ADDENDUM NO. 2

The following items shall become a part of the Construction Documents for the referenced project dated November 14, 2016.

James Nightingale, AIA  
Howard & Helmer architects p.a.

December 6, 2016

**CLARIFICATIONS:**

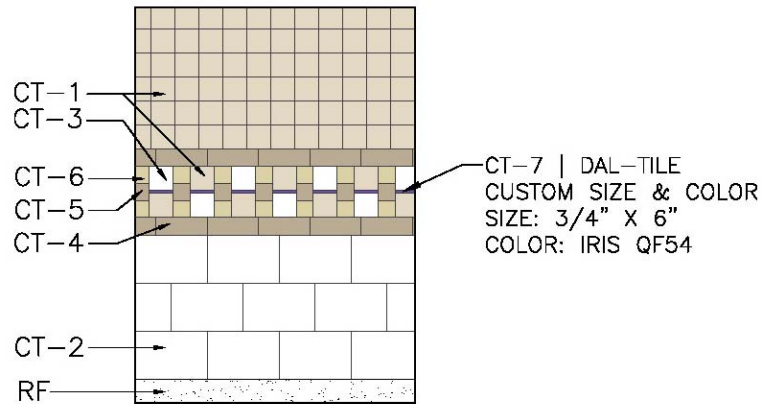
- 1. Ceiling projector mount to be Classroom Technology Solutions AVM-PRO-DCP-UNV-202-WH or approved equal. (ctsed.com)
- 2. Add a note to each building Finish Schedule to indicate that all wall, floor and ceiling finishes shall meet the flame and smoke development criteria of IBC Chapter 8.
- 3. Electrical Contractor shall provide and install (1) Cat 6a cable between teacher's desk (plan note 10) and the USB drop shown below the marker board. Typical all new classroom additions at all schools.
